Access Compliance Report Public Rights-of-Way (Curb Ramps)

Main Street: N/A Cross Street: ANTONIO_PKWY Location: NW

ADA ID: RPRK220223140034 Ramp Type: Type 1 - Perpendicular Initial Pass/Fail: Fail Overall Compliance: No Severity Score: 16

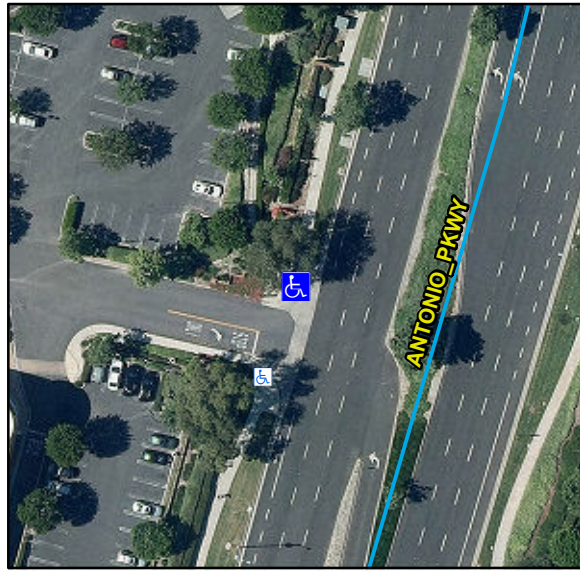
Compliance	Description	Data	Compliance	Description	Data
N/A	Ramp Length (in)	113	N/A	Flare Type LT	
Yes	Ramp Width (in)	48			N/A
No	Ramp Run Slope (%)	8.9	N/A	Flare Slope LT (%)	N/A
No	Ramp Cross Slope (%)	2.3	N/A	Flare Traversable LT	N/A
N/A	Landing Present	N/A	N/A	Flare Type RT	
N/A	Landing Length (in)	N/A			N/A
N/A	Landing Width (in)	N/A	N/A	Flare Slope RT (%)	N/A
N/A	Landing Run Slope (%)	N/A	N/A	Flare Traversable RT	N/A
N/A	Landing Cross Slope (%)	N/A	N/A	DWS Provided	N/A
N/A	Landing Movement Obstructed?	N/A	N/A	DWS Contrast	N/A
	Landing Movement Type	N/A	N/A	DWS Length (in)	N/A
N/A	Landing Shared	N/A	N/A	DWS Full Width	N/A
N/A	Clear Space	N/A	N/A	DWS Offset Left (in)	N/A
N/A	Clear Space To Crosswalk (in)	N/A	N/A	DWS Offset Right (in)	N/A
N/A	Marked Crosswalk 1	No	N/A	Marked Crosswalk 2	N/A
	Crossing 1 Direction	S		Crossing 2 Direction	N/A
	Marked Crosswalk 1 Width (in)	N/A		Marked Crosswalk 2 Width (in)	N/A

N/A	Ramp Inside Crosswalk 1	N/A	Yes	Ramp Inside Crosswalk 2	N/A
	Crossing 1 Slope (%)	4.5		Crossing 2 Slope (%)	2.3
	Crossing 1 Cross Slope (%)	3.3		Crossing 2 Cross Slope (%)	1.5
N/A	Gutter Ponding	N/A	N/A	Curb Slope	1.2
Yes	Gutter Lip Height (in)	0		Road Run Slope (%)	1.1
N/A	Gutter Run Slope (%)	N/A		Road Cross Slope (%)	3.1
N/A	Gutter Cross Slope (%)	N/A			
Yes	Overall Surface Condition: Acceptable		Yes	Perp Joint Present	Yes
	Cross Gutter Present?	Yes		Spandrel Present?	Yes
	Replace Cross Gutter?	No		Replace Spandrel?	No

Remove & Replace Entire Ramp.

R304.2.2, R304.5.3, STD 1115
